June 15, 2012

Yukon Government
Faro Mine Remediation Project
Suite 2C-4114-4th Ave
PO Box 2703 (K-149)
Whitehorse, Yukon Territory
Y1A 2C6

Faro Mine Complex
2011 Annual Geotechnical Review

LITTLE CREEK DAM
SECTION B-B

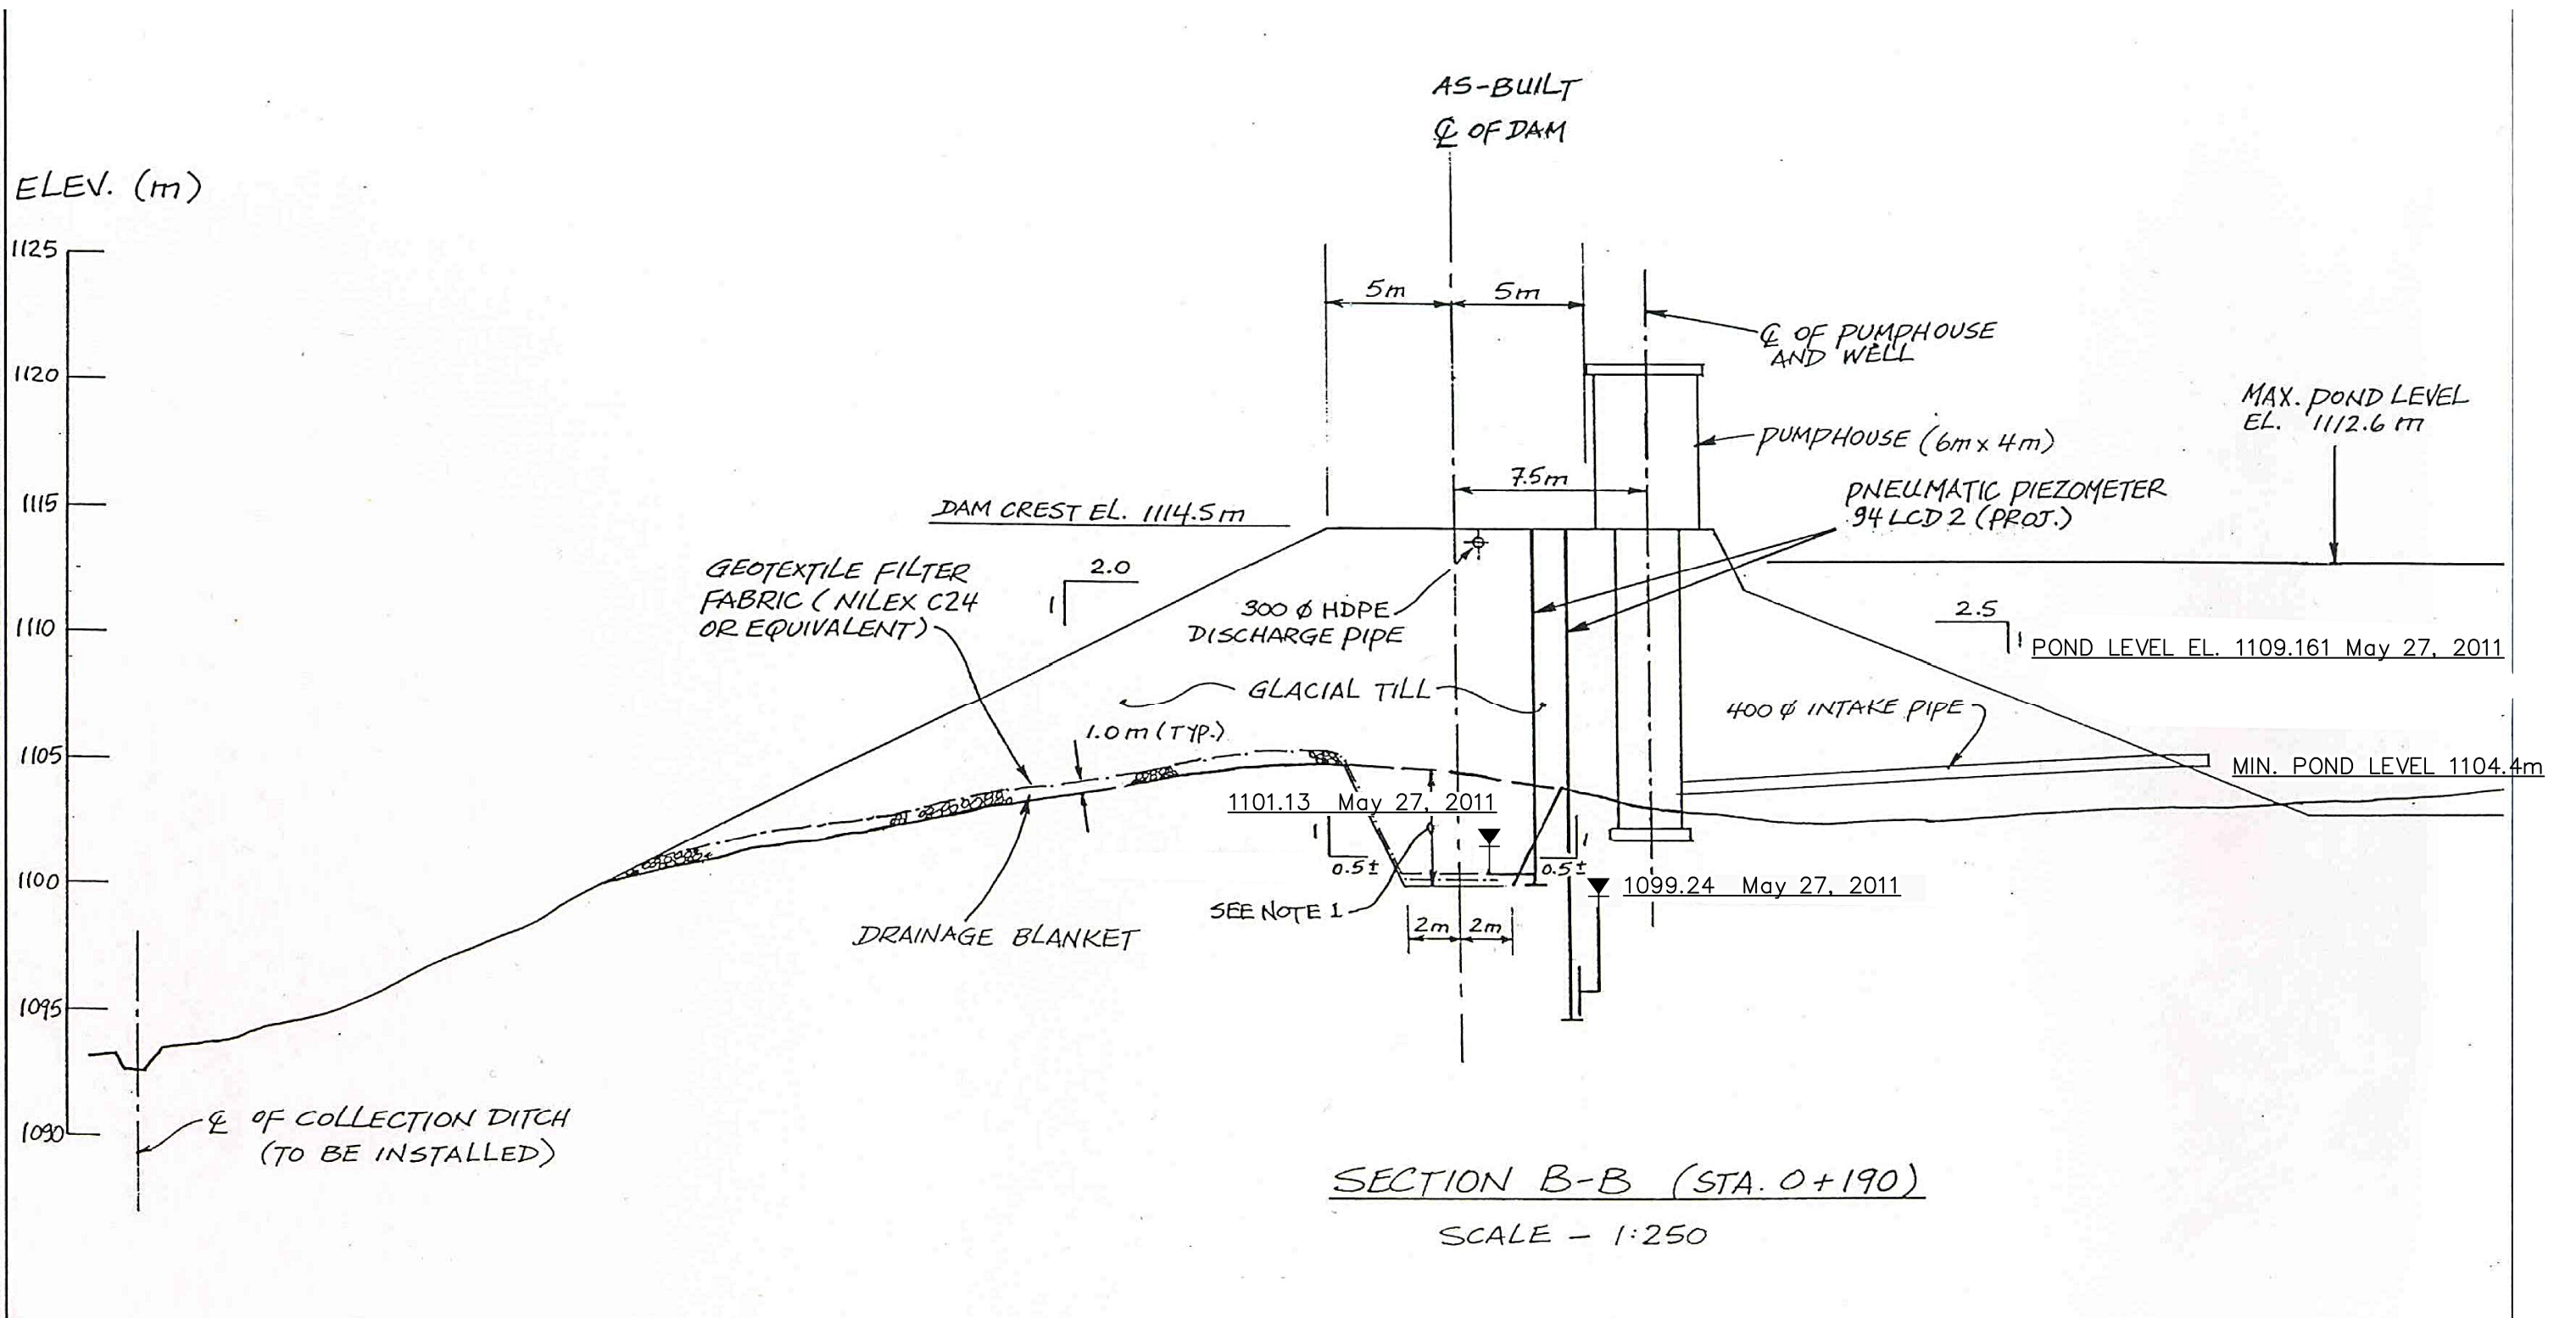
- Consider repair of rill erosions on both dam slopes.
- Seasonal variation of pond level to be shown on all piezometric-level plots to assist the interpretation of piezometric response to pond level variation.

- For the BH94 series of pneumatic piezometers (LCD-1 to LCD-3 shallow and deep piezometers), the piezometric levels either show a downward trend (LCD-1 shallow and deep) or are in a range consistent with historical variations (LCD-2 and LCD-3 shallow and deep).

- In general, BH94- series piezometers located along the dam crest show piezometric levels fluctuating with the pond level, while P09- series piezometers located along the downstream dam toe only show minor variation of piezometric level, with the exception of P09-LCD-4.

Faro Pit

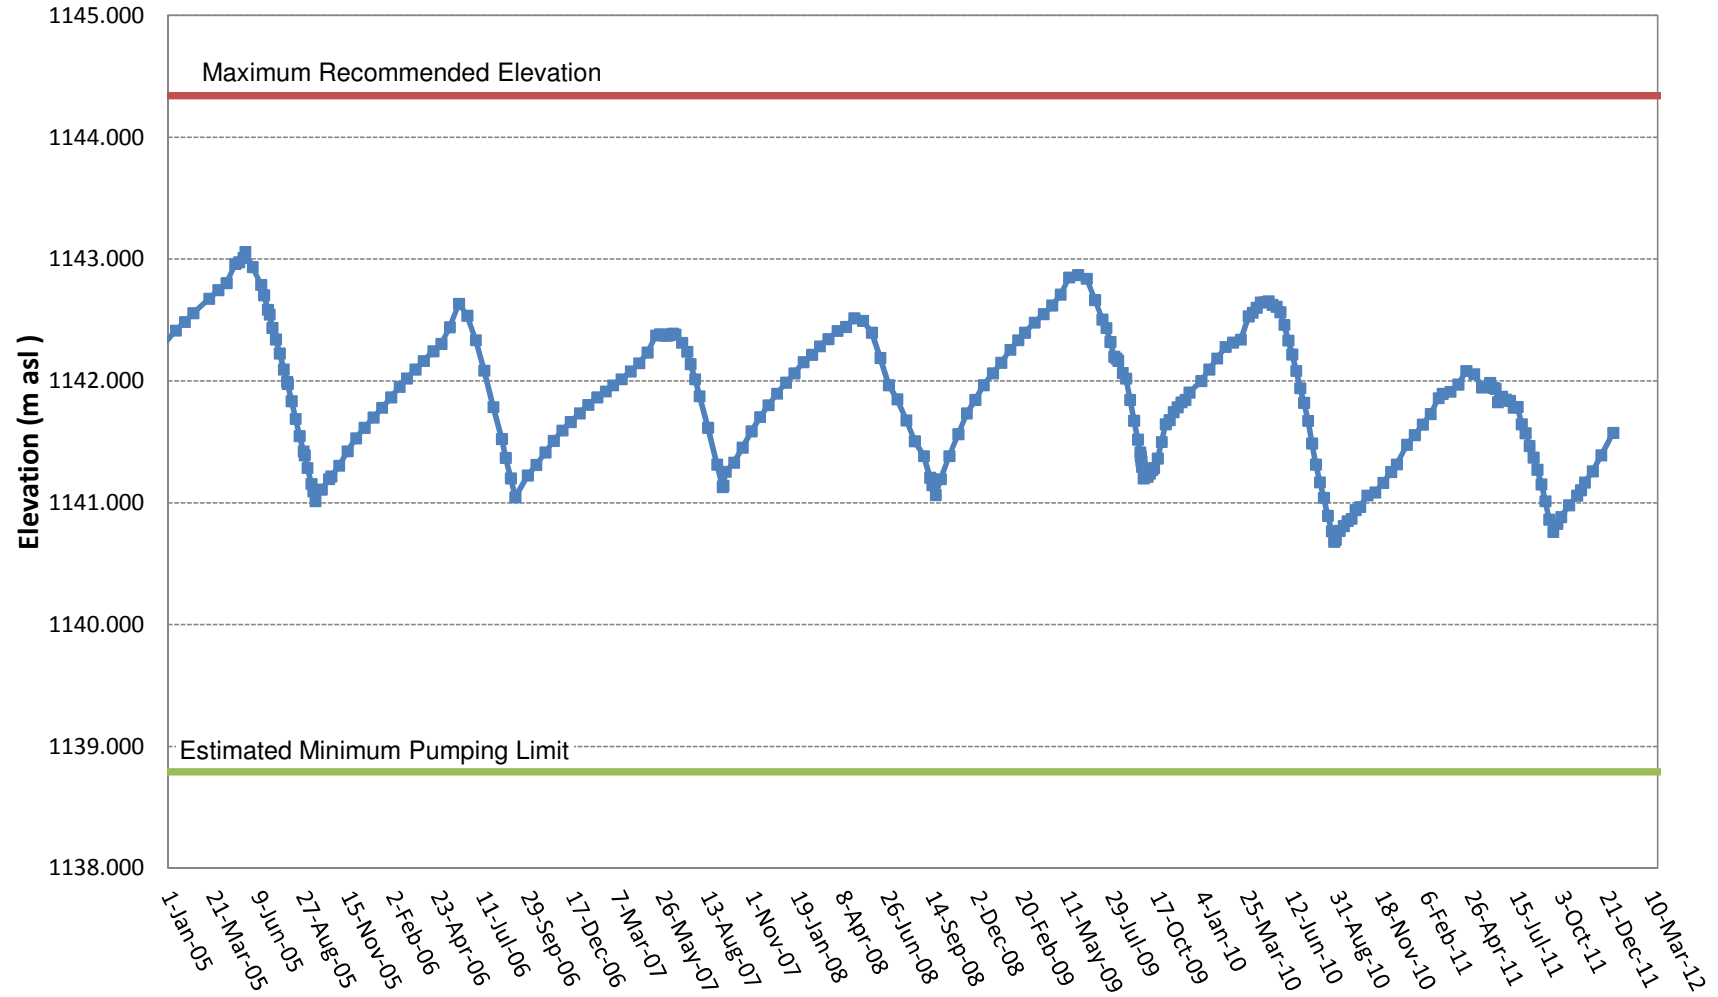
- Pit wall regression (Section II-A.2) –The measured relative distances between reference bars and the pit wall brim have been similar for six bars (#15351 to #15356) from 2008 to 2011, and for three newly installed bars (#15717, #15737 and #15742) from August to November 2011. Locations of the three new reference bars should be added on Figure 6 to aid interpretation. Readings for Bar #15351 in 2011 continue to be the same as those readings taken after June 24, 2010. The apparent difference in readings of about 2 m from June 24 to July 10, 2010 was attributed to potential error in the bearing of measurement distance (Golder 2011a). It appears that similar errors could also exist in readings for Pin #15352. In general, a trend of slightly decreasing distance can be discerned from these measured distances since 2008, except those readings for Bars #15351 and

- Pit wall prism monitoring (Section II-A.3) – The ordinates of change in northing and easting for the prism monitoring plots should be “cm” instead of “m”. The scatter of the nine data points for the change in northing and easting plots seems to increase from 2 cm in October 2006 to 3 cm in August 2009. The scatter in the northing-change plot increases further to 5 cm in September 2010 and 2011, and the scatter in the easting-change plot remains at about 3 cm in September 2010 and 2011. It is uncertain whether these changes in scatter are related to prism position/survey accuracy issue or pit wall movement. Moreover, two prisms located uphill of the Faro Creek Diversion Channel (Points #13875 and 13877) were considered by Golder (2011a) not likely to move. However, they experienced “apparent change” of 2 cm to 3 cm in northing and 3 cm to 7 cm in easting from 2006 to 2011. The above observations may indicate that these “measured changes” could reflect the accuracy of these surveys rather than real pit wall movements.
